**Re: Second Submission Review – Gun Club Data Center – Site Plan & Plat**  
Application Number: **DA-2231-04**  
Case Numbers: **2021-6004-00**

## Second Submission Review

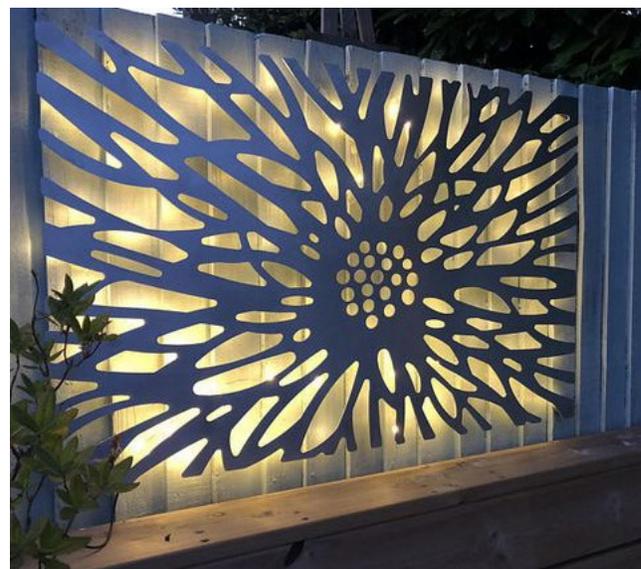
3D. *Repeat comment:* The architecture as proposed does not meet the design standards of the Master Plan. The site lies in Planning Area 5, also known as the “Venture” area. These land uses should focus on

modern functionality while also achieving quality design. Facades facing public spaces shall be architecturally appealing with the encouraged use of unique lighting, colors, and textures. The example provided in the design guidelines references scoring, articulated facades, windows, a stepped parapet as well as changes in color. Commercial, Office Use sites shall have landscape at defined entrances for a welcoming feel and aesthetic. Large scale, long commercial/office/flex buildings within this district shall also utilize vertical articulation as noted in Form H to create visual interest and reduce the overall appearance of mass. The following standard is included in the design guidelines: “Tilt-up concrete for Commercial, Entertainment, Restaurant, Retail Uses and Big Box Retail Buildings. Tilt up concrete should be articulated to provide visual interest and reduce overall appearance of mass, or reference building materials section above. Refer to UDO section 4.8.5.B and UDO table 4.8-3 for allowed articulation methods.”
